TOWN OF WEST WARWICK
REQUEST FOR PROPOSALS (RFP)

GENERAL CONTRACTOR
30 Payan Street Renovation

ADDENDUM #2
Posted 2/12/2026

RFQ/P REFERENCE NUMBER: 2026-08
RFP RELEASE DATE: January 27, 2026

INTERIOR AND EXTERIOR STOREFRONT SYSTEM

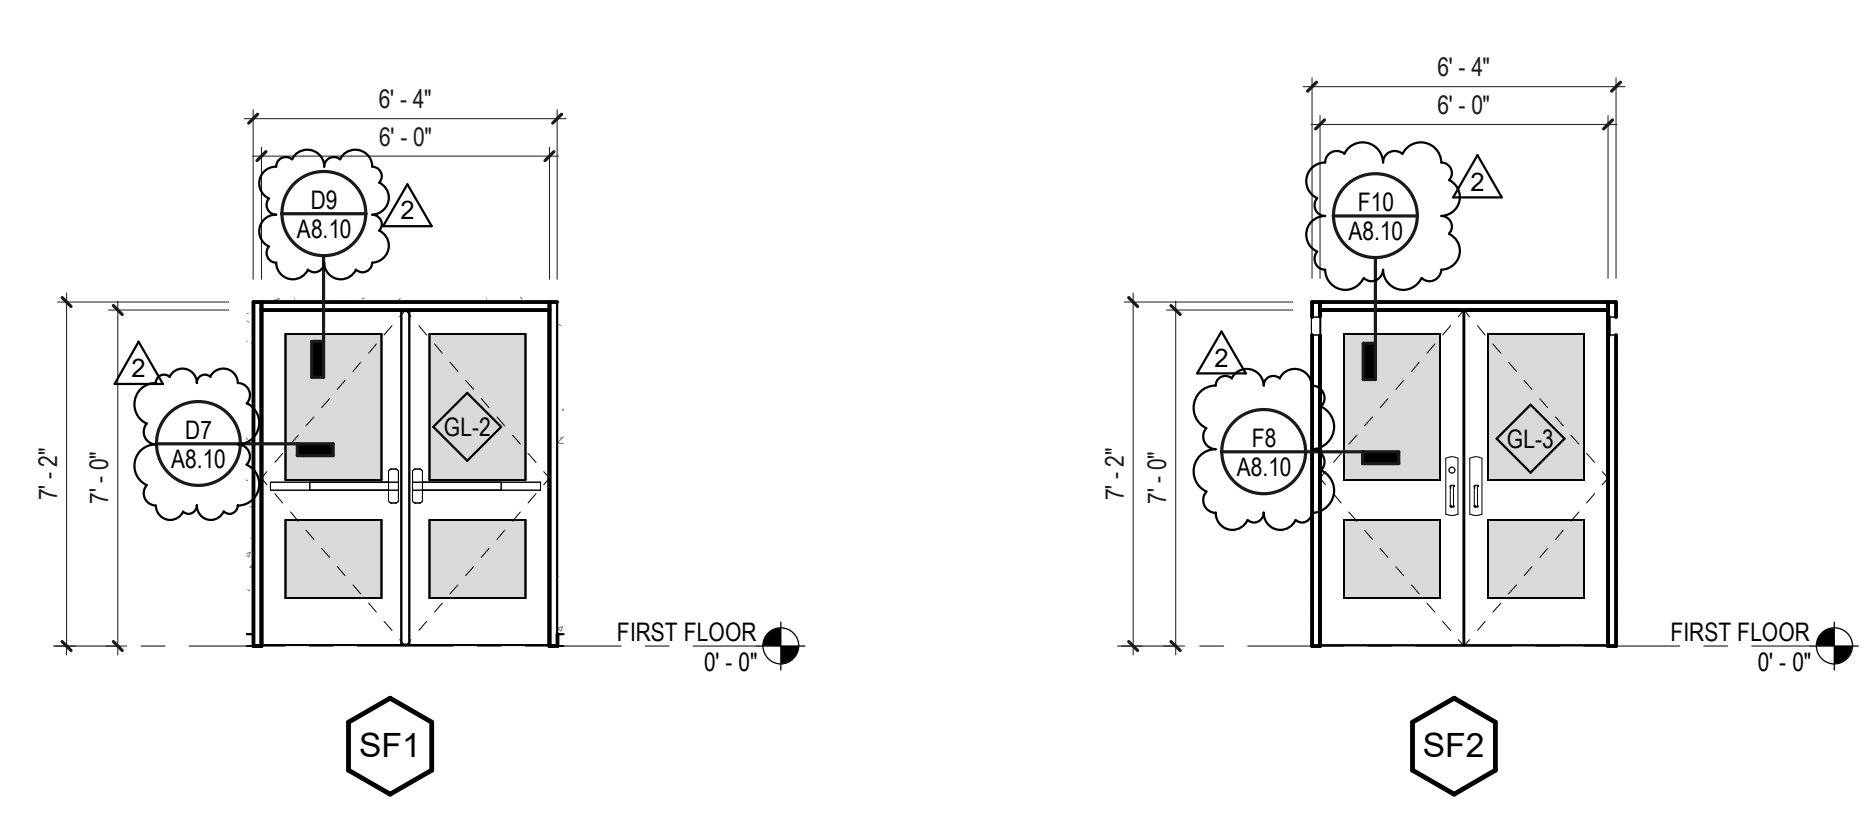
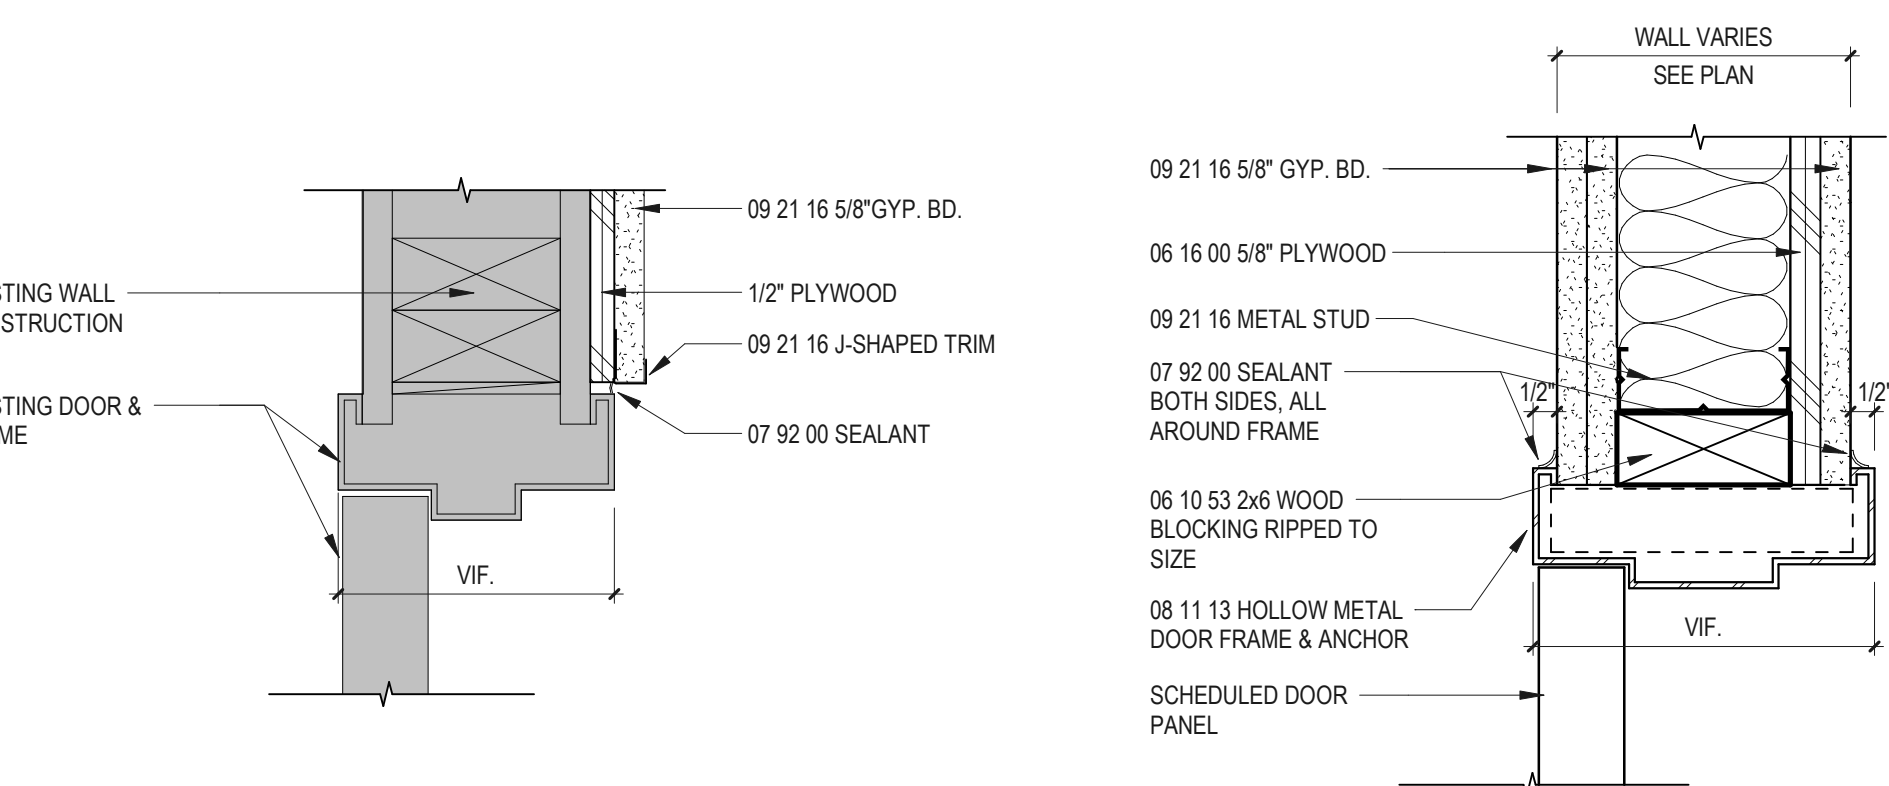
- Added storefront jamb detail at F8 and head detail at F10 for existing exterior wall.
 - Referenced storefront jamb and head details at SF1 and SF2.
 10. I2.10 FINISHED PLANS & MATERIALS LIST

K12 FIRST FLOOR FINISH PLAN

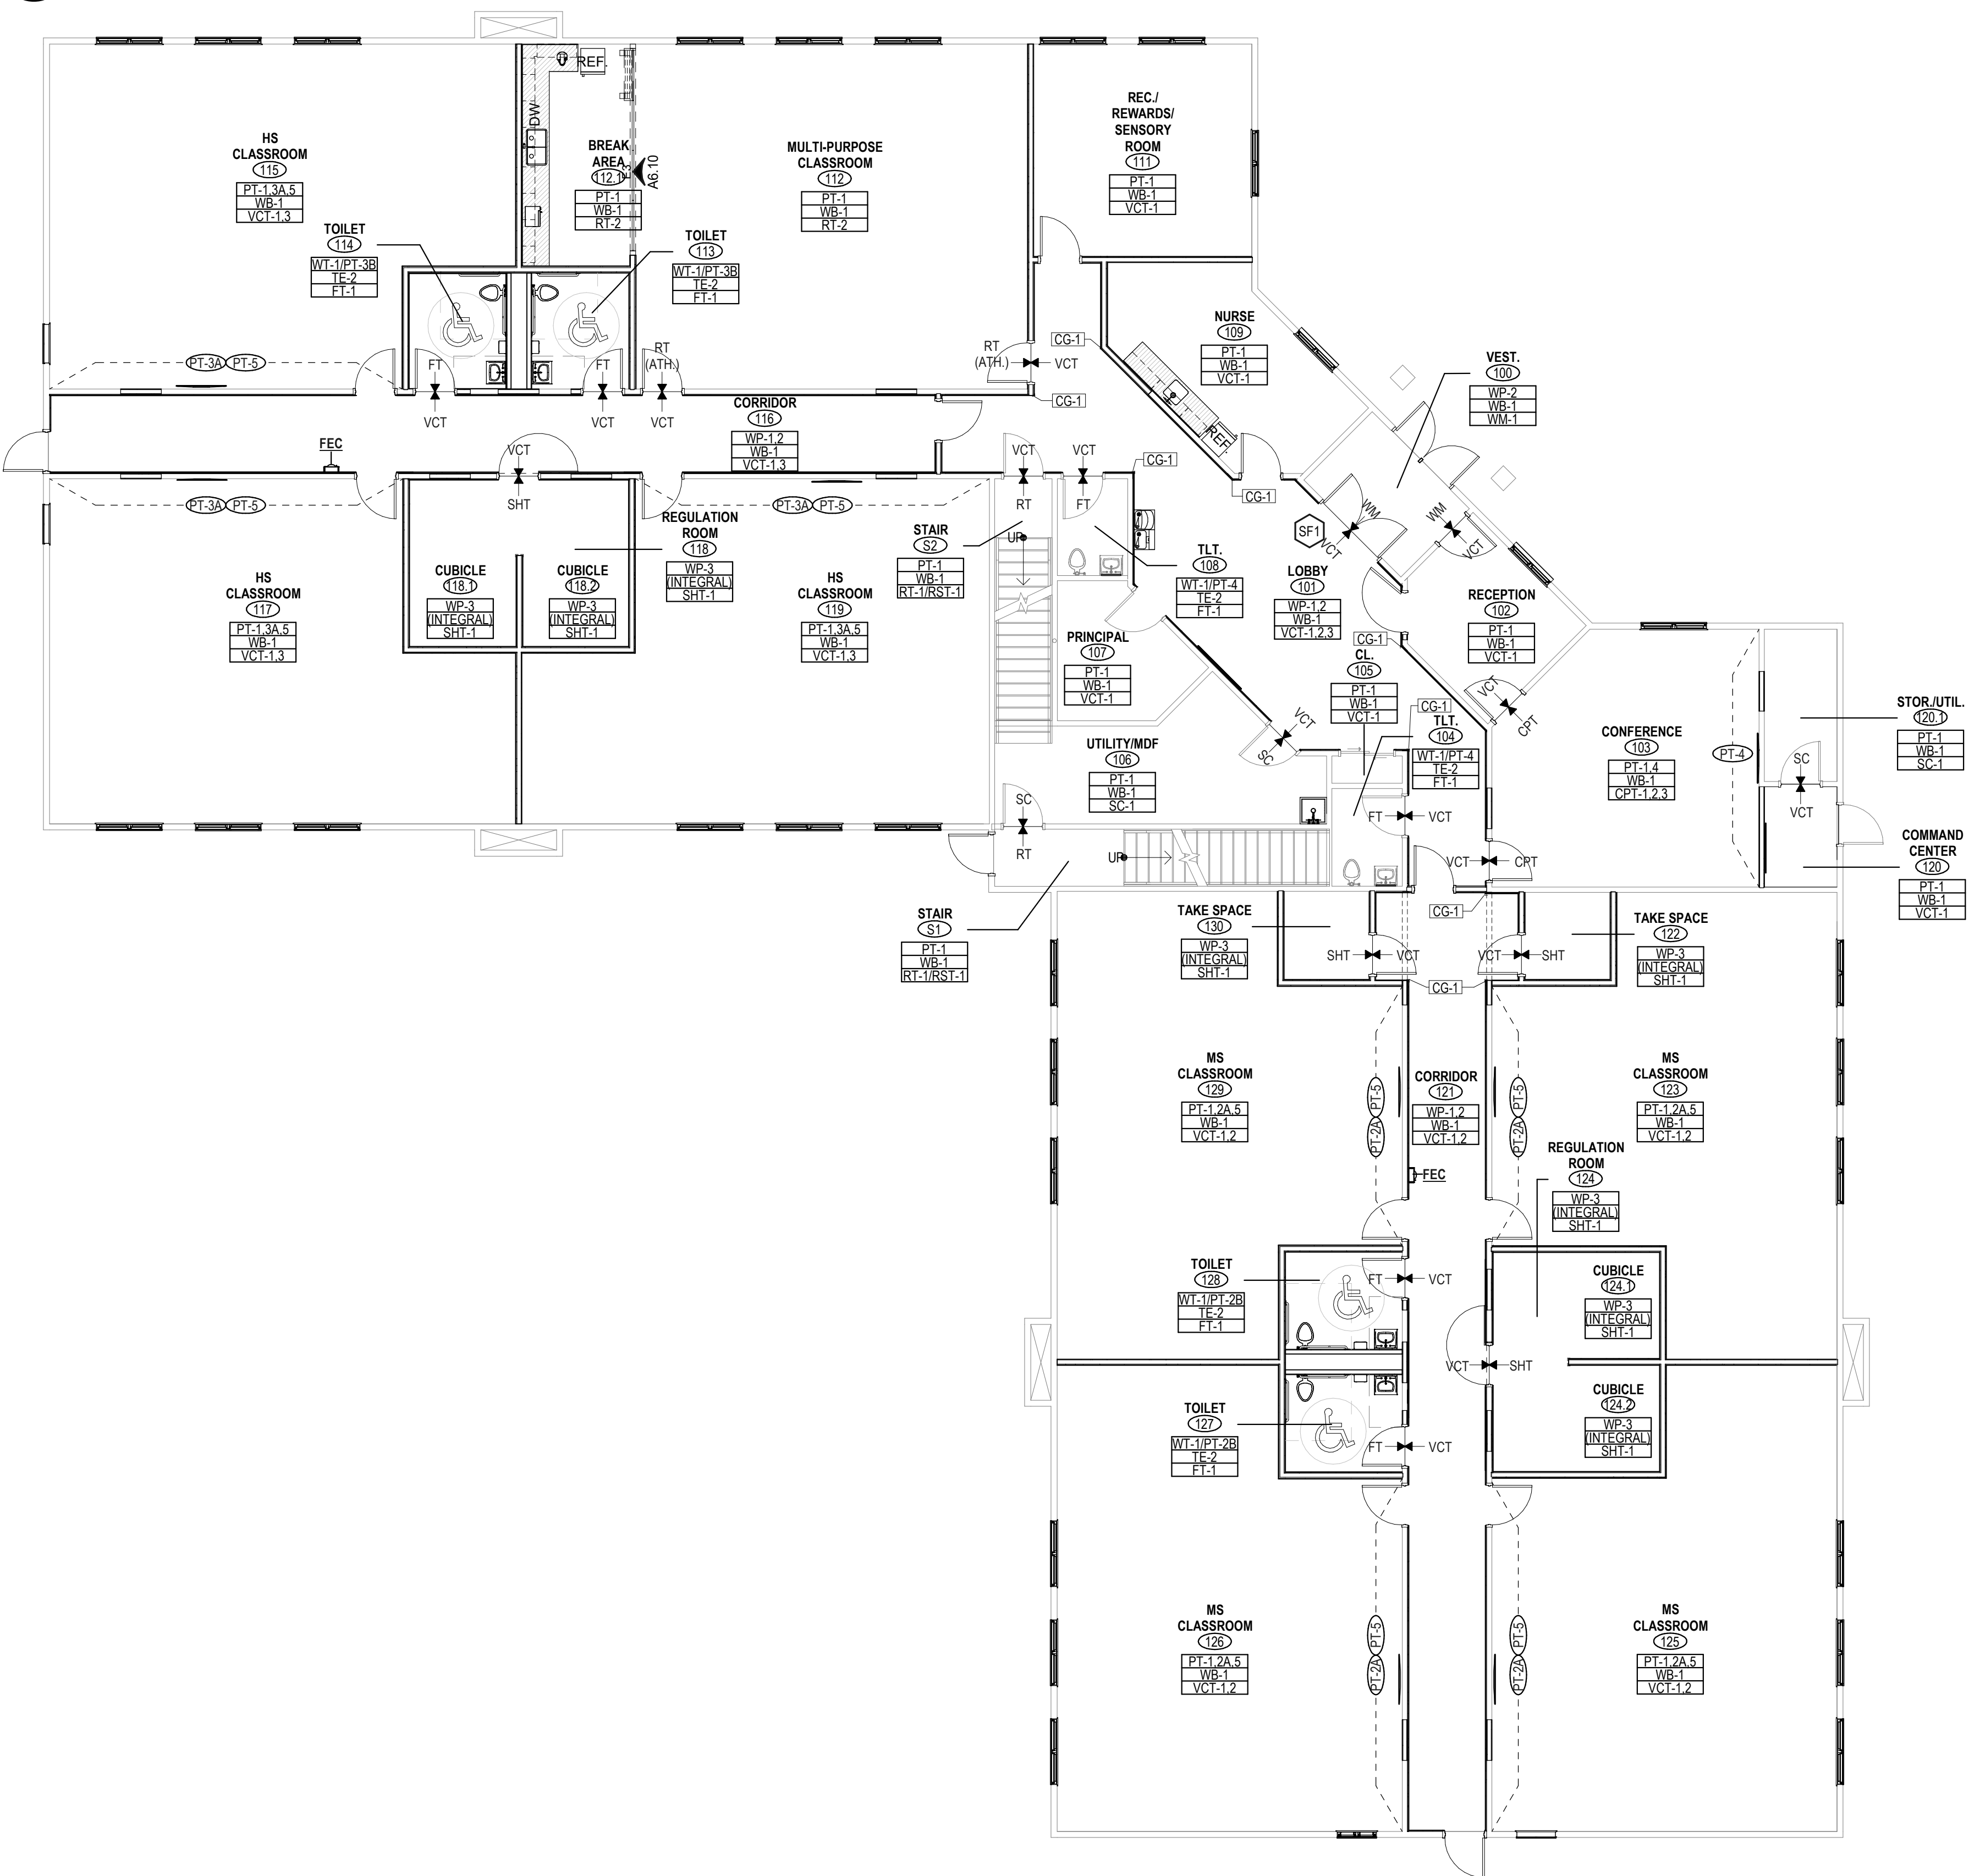
- Removed window glazing films WF-1 and WF-2 per RFI A-27.
 - Modified Solid Surface SS-1 to be applicable for wall caps for H-1 wall types.
 - Added Granite Countertop GR-1 on Materials List per RFI A-08.

1 FIRST FLOOR CEILING PLAN
FP2.01 SCALE: 1/8" = 1'-0"

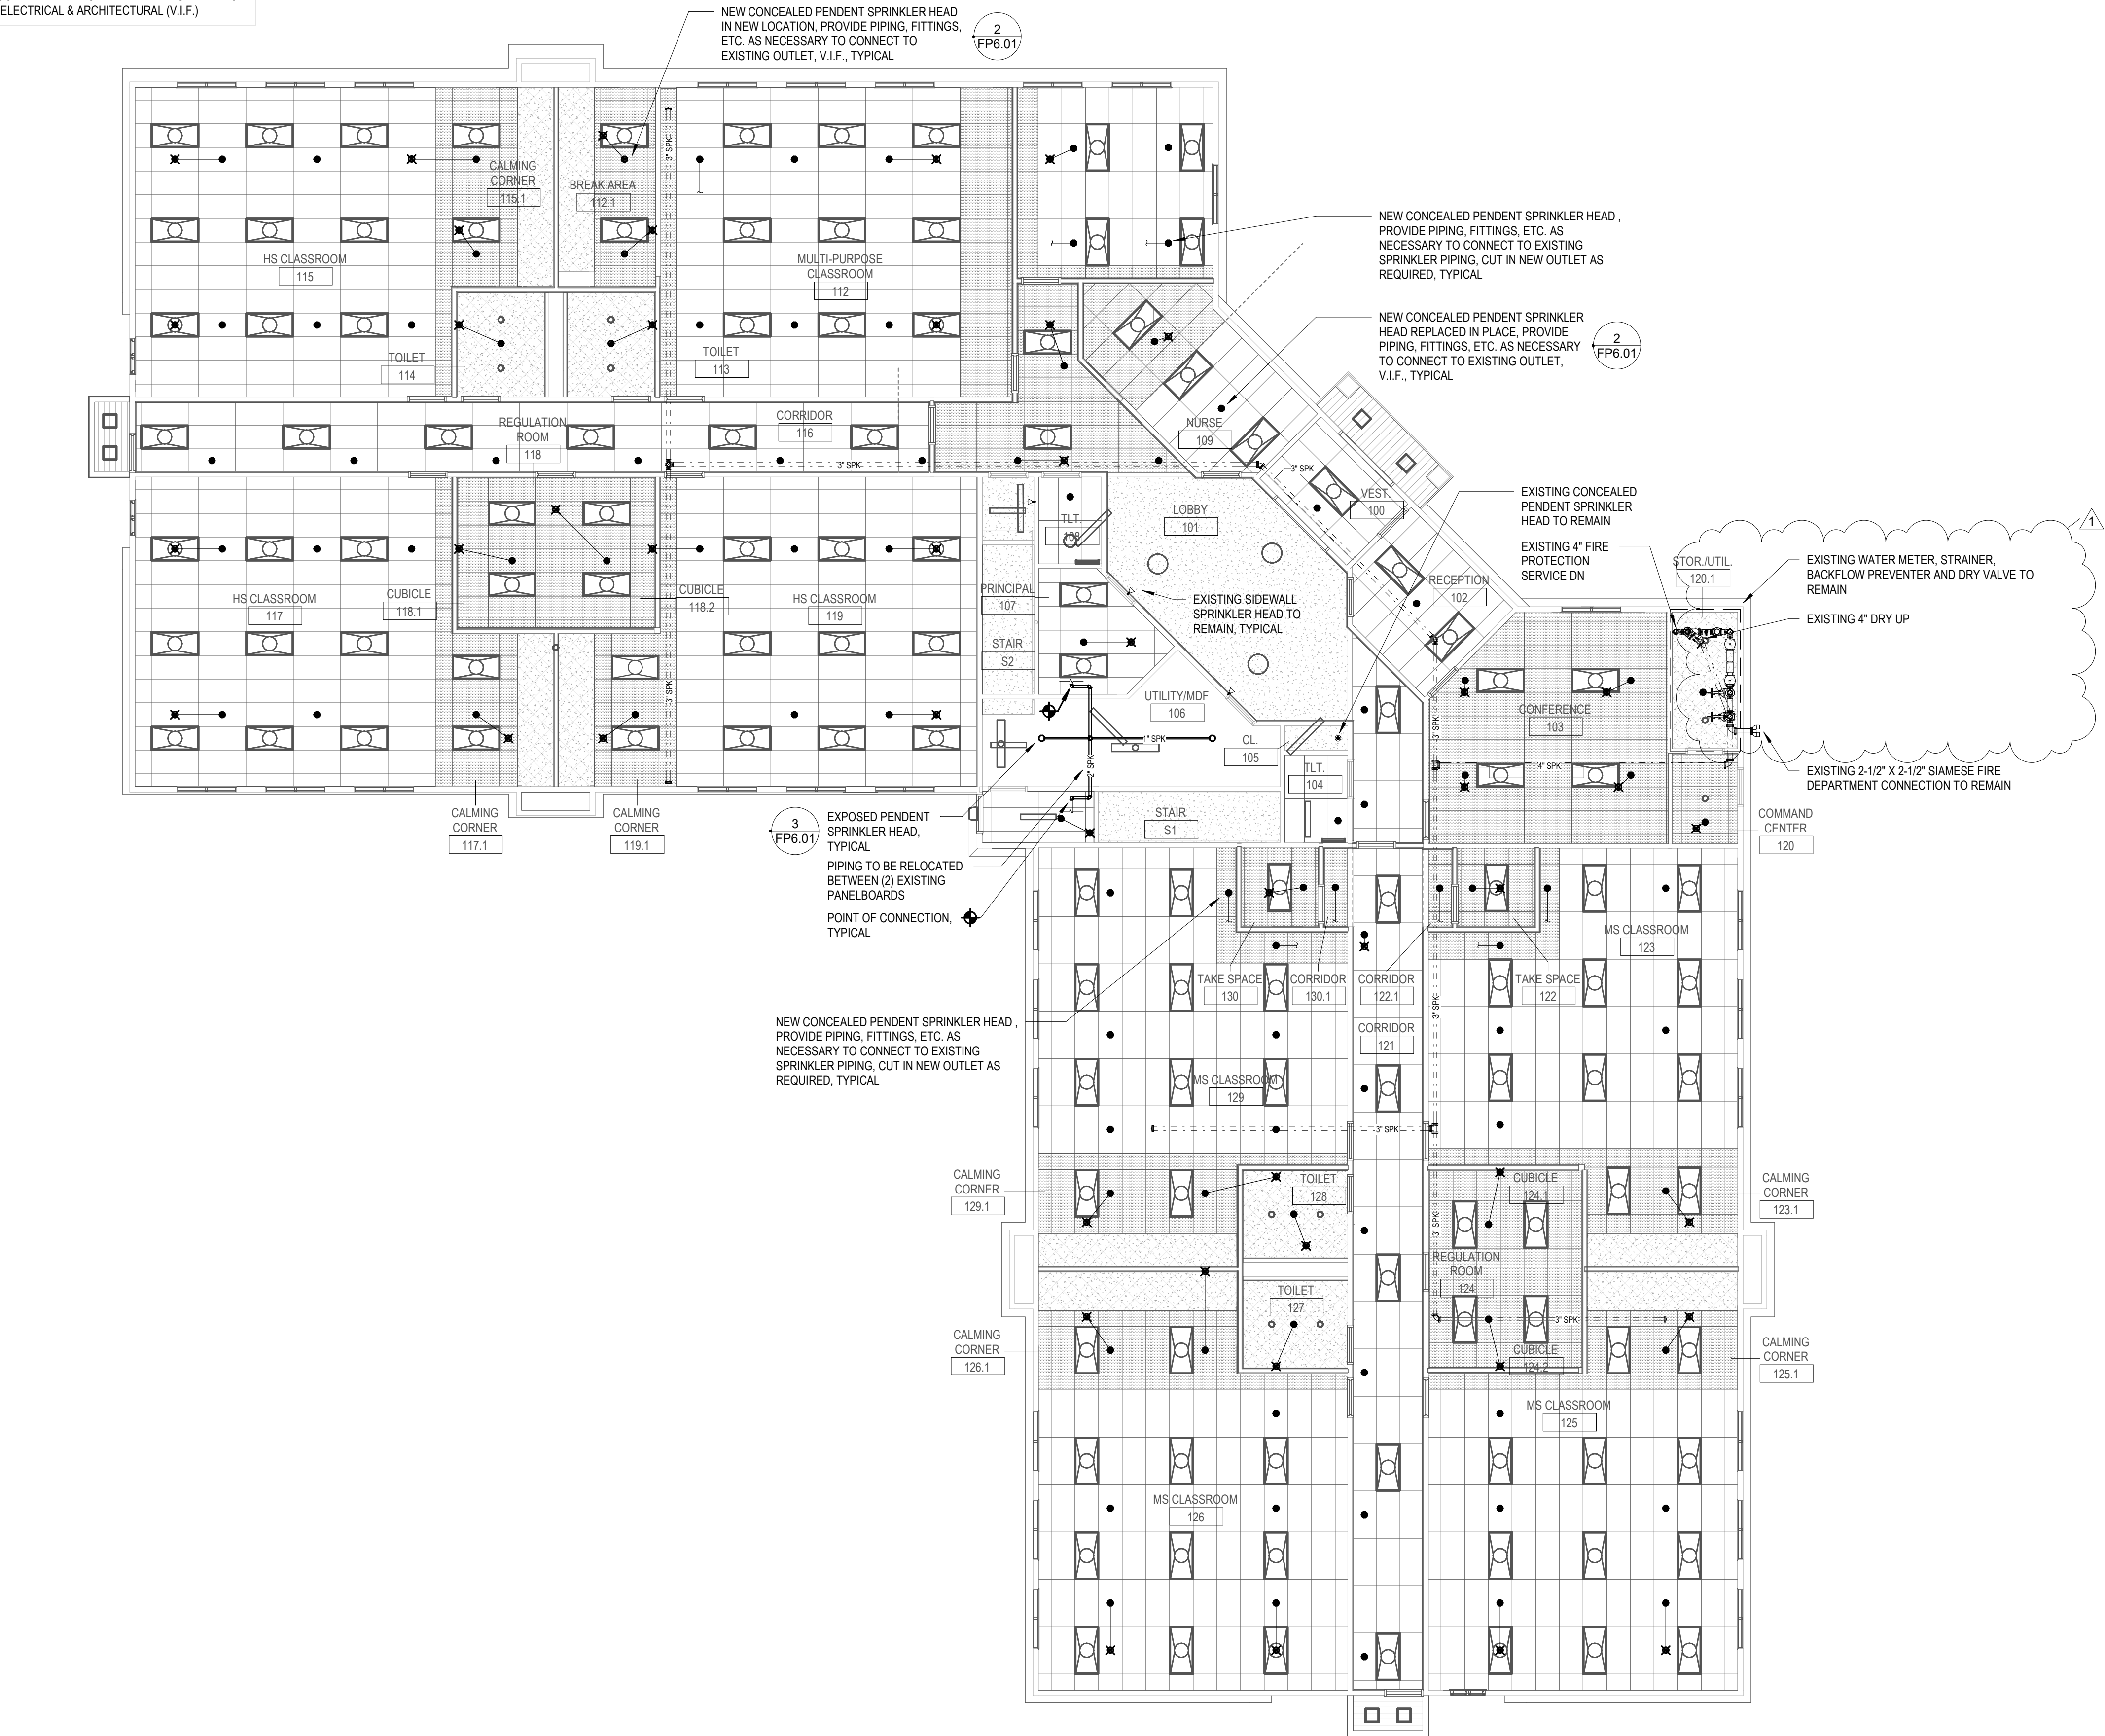
11. FPD2.01 FIRST FLOOR DEMOLITION – FIRE PROTECTION
 - Removed demolition of existing backflow preventer.
12. FP2.01 FIRST FLOOR CEILING PLAN – FIRE PROTECTION
 - Removed installation of new backflow preventer.
13. FP5.01 SCHEDULES – FIRE PROTECTION
 - Removed backflow preventer schedule.
14. FP6.01 DETAILS – FIRE PROTECTION
 - Removed horizontal double-check detector backflow preventer detail.
15. P5.01 SCHEDULES - PLUMBING
 - Added mixing valve model to L1 in Plumbing Fixture & Equipment Schedule.
16. M1.01 FIRST FLOOR PLAN - MECHANICAL
 - Indicated return grille airflows.
17. E0.01 COVER SHEET – ELECTRICAL
 - Added pressure switch to symbol list.
18. E1.01 FIRST FLOOR PLAN – ELECTRICAL
 - Revised storage room 120.1 to provide new tamper, flow, and pressure switches for the existing to remain backflow preventer.
